10461 Hook Lane, Pagham

Technical Note 4 Rv01: Response to LLFA Comments on RMA

31st March 2021

| Appendix D – Diverted Watercourse Long Section

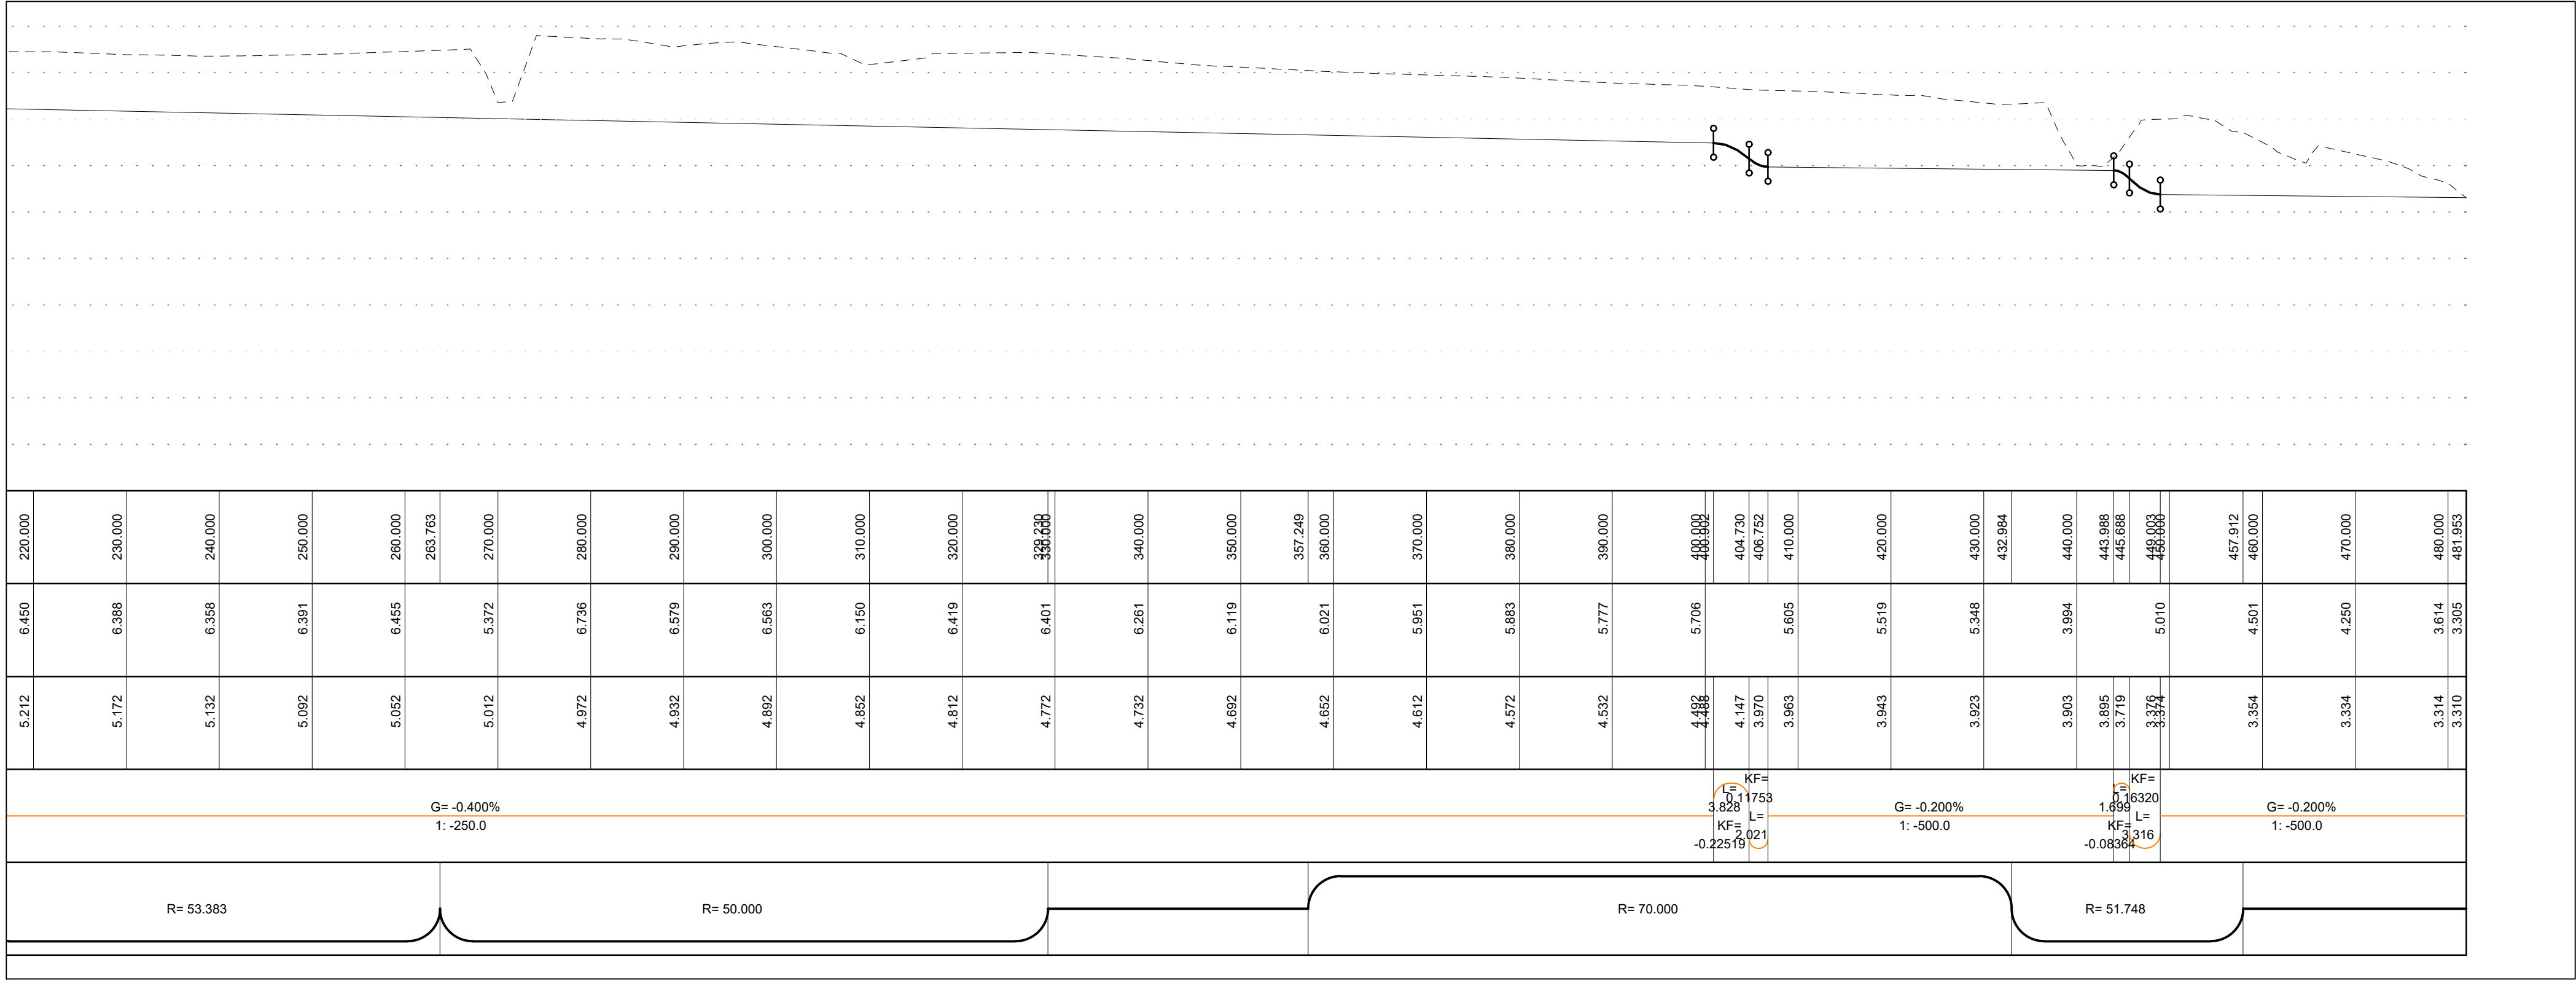
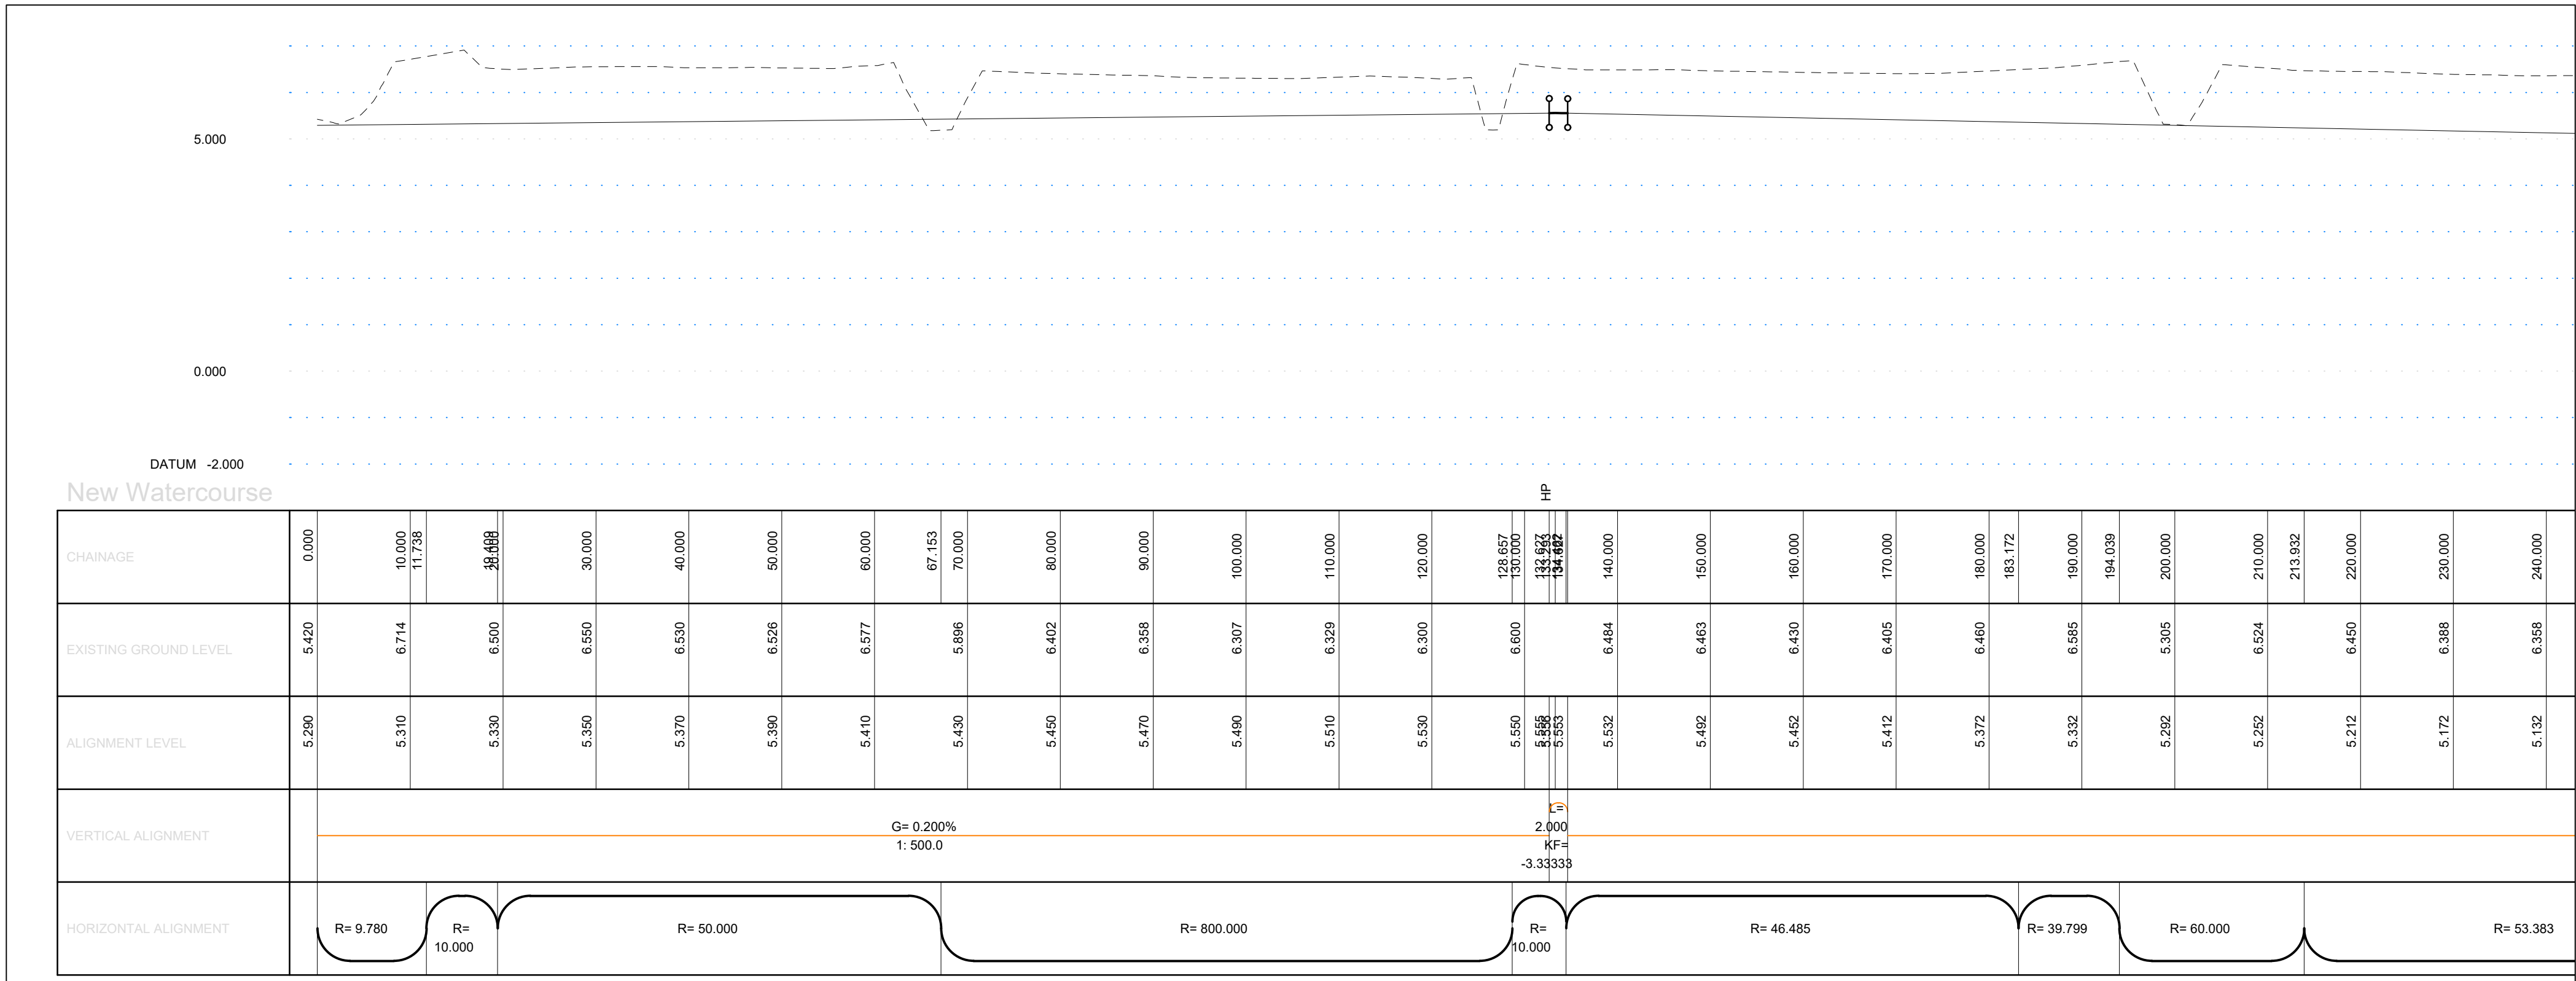
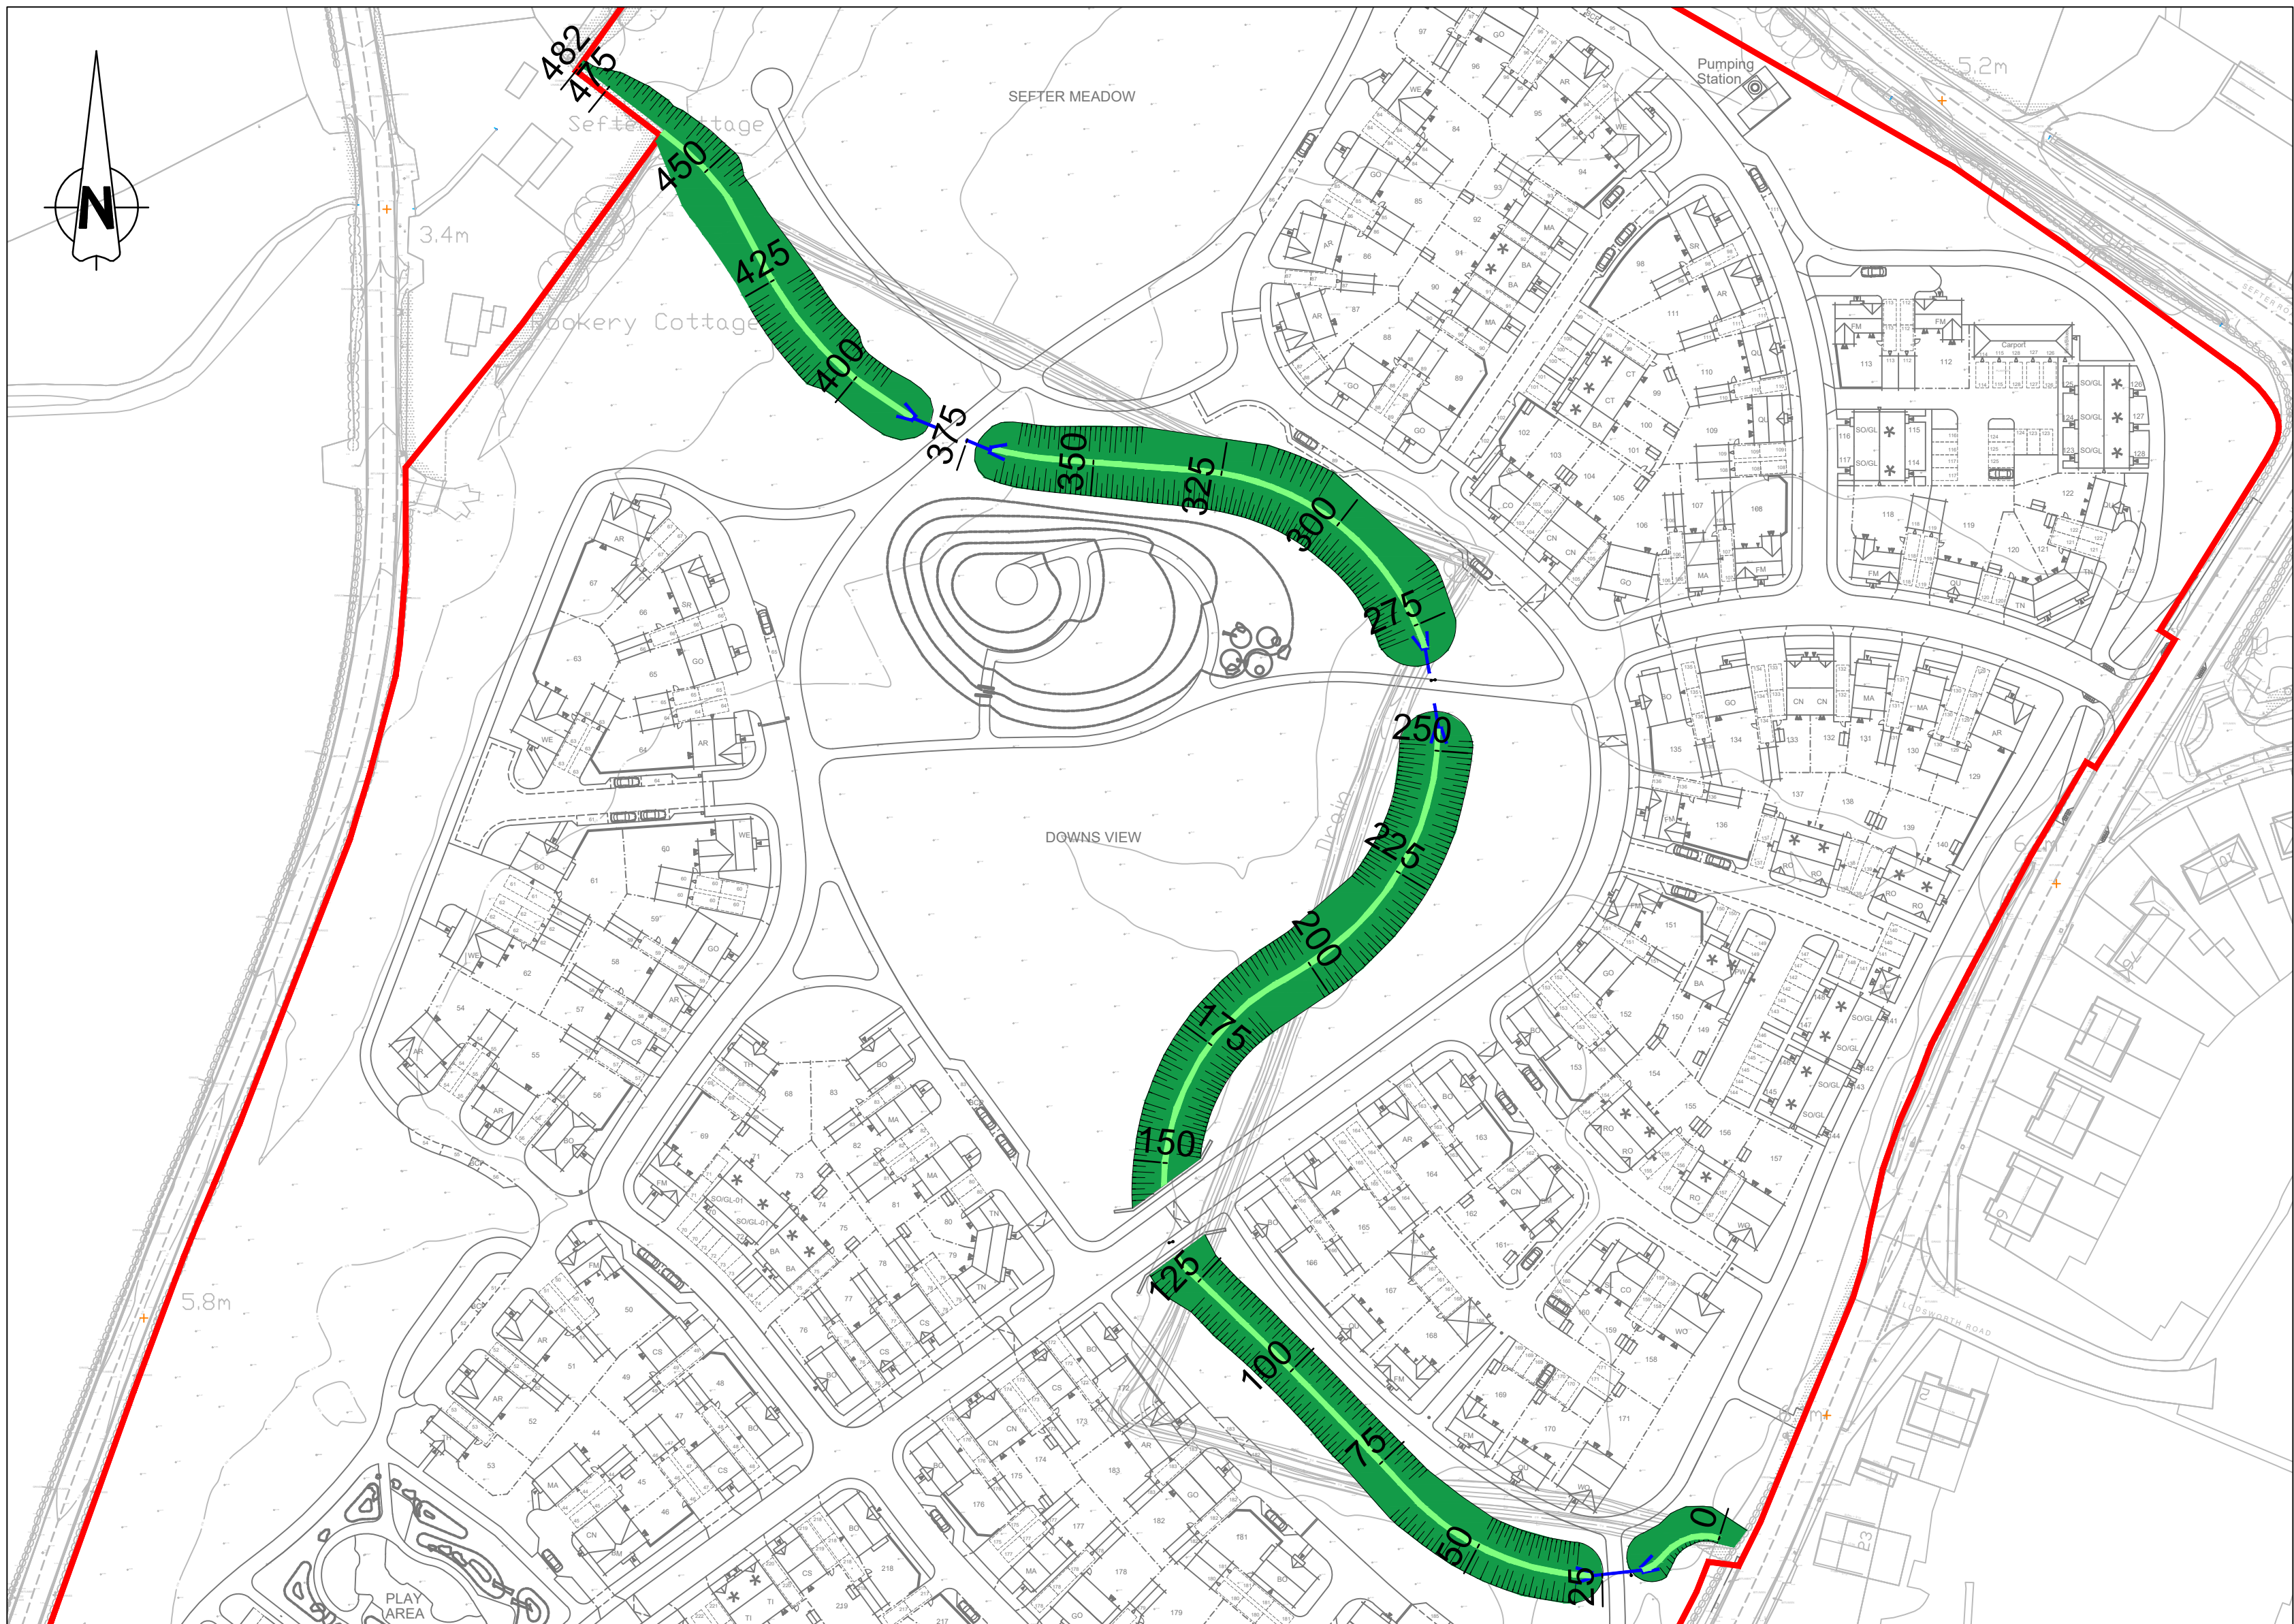
2.5 If the proposed swale referenced in point 2 above is proposed to replace the watercourse we will require a long section of the proposed swale to be provided to evidence if the proposals to divert the watercourse are acceptable, and therefore if the proposed site layout is acceptable. Levels of upstream and downstream watercourses must be provided

2.5.1.1 *Your proposals for the swale show a downstream invert level of 3.29. But on the topographic survey levels are currently 3.78-3.66 in this area. Without knowing the culvert invert levels in the area and the downstream watercourse levels it is not possible to know whether this is achievable in practice*

2.5.1 Please refer to the appendix for a long section of the diverted watercourse. We have endeavoured to mirror the existing longitudinal profile as far as reasonably practicable.

| Appendix G – Existing Watercourse Long Section

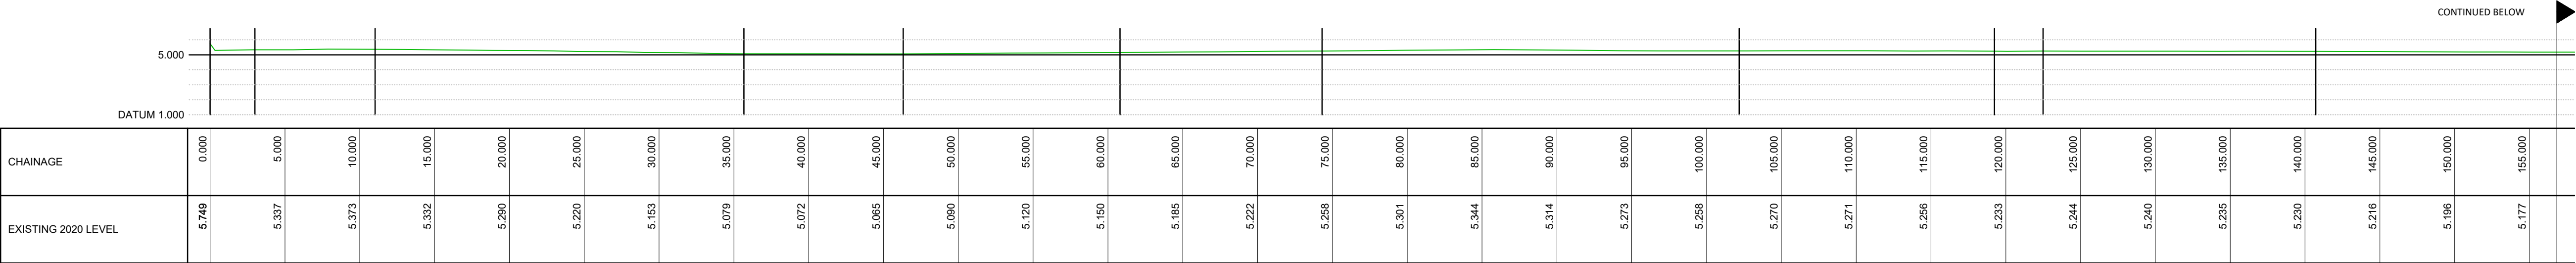
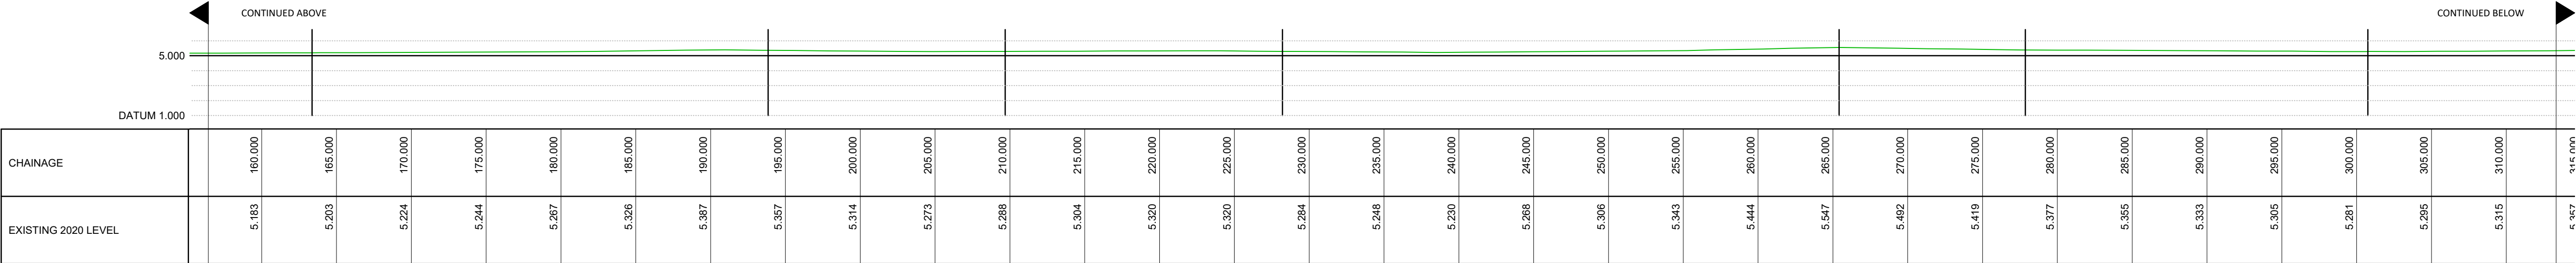
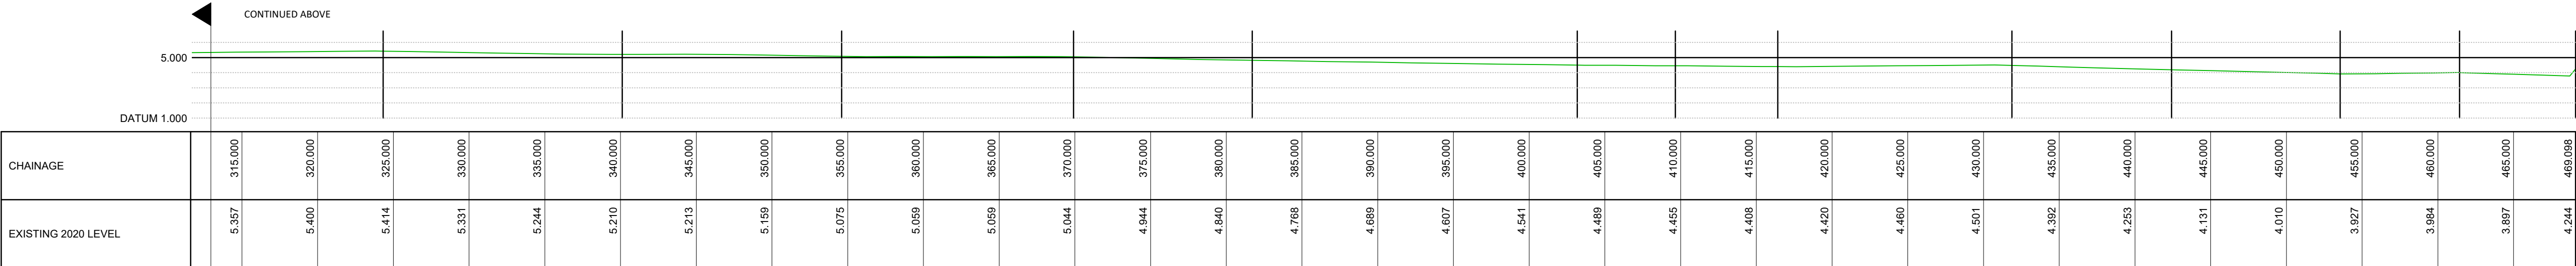
- 2.5.1.4** *It would be useful to have a long section of the existing watercourse. So that comparisons of length of watercourse and falls can be completed more easily.*

Long section prepared and appended.
